Product Change Notification / GBNG-03JWKQ486

CCB 4443 Final Notice: Qualification of G631HQ mold compound material for selected Atmel AT32UC3Axxx and AT32UC3Cxxx device families available in 144L LQFP (20x20x1.4mm) package at ANAP assembly site.

PRE AND POST CHANGE SUMMARY
CCB 4443

Pre Change

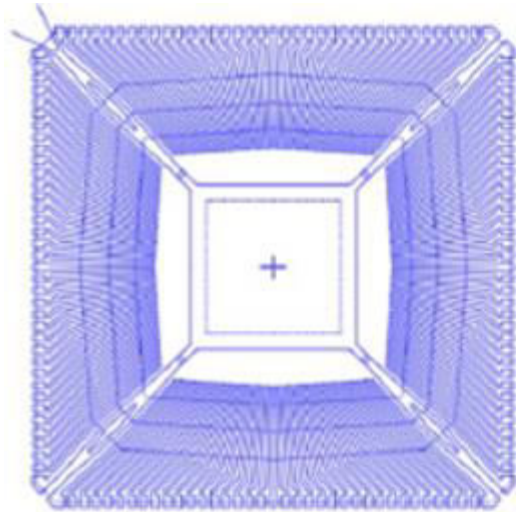
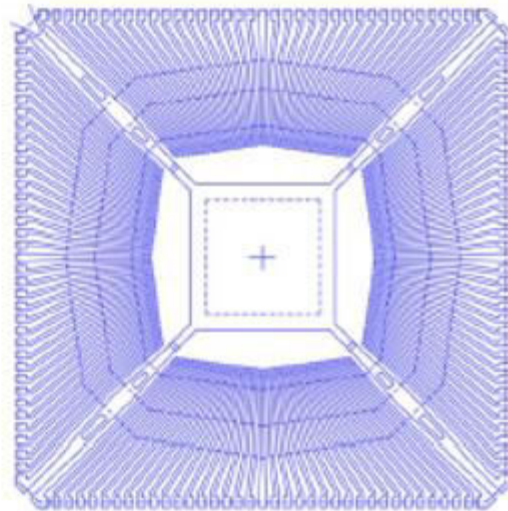
Strip Density	HDLF High Density Lead frame	HDLF High Density Lead frame
LF Paddle Size	276x276 mils	236x236 mils
DAP Surface Prep	Double Ring Ag	Double Ring Ag
Backside Dimple	Yes	Yes

Post Change

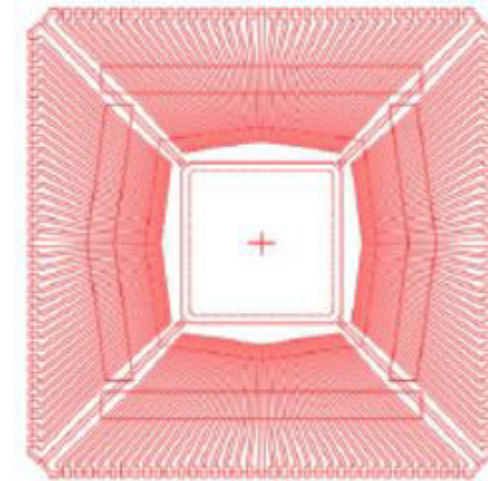
Strip Density	UDLF Ultra Density Lead frame
LF Paddle Size	276x276 mils
DAP Surface Prep	Double Ring Ag
Backside Dimple	No
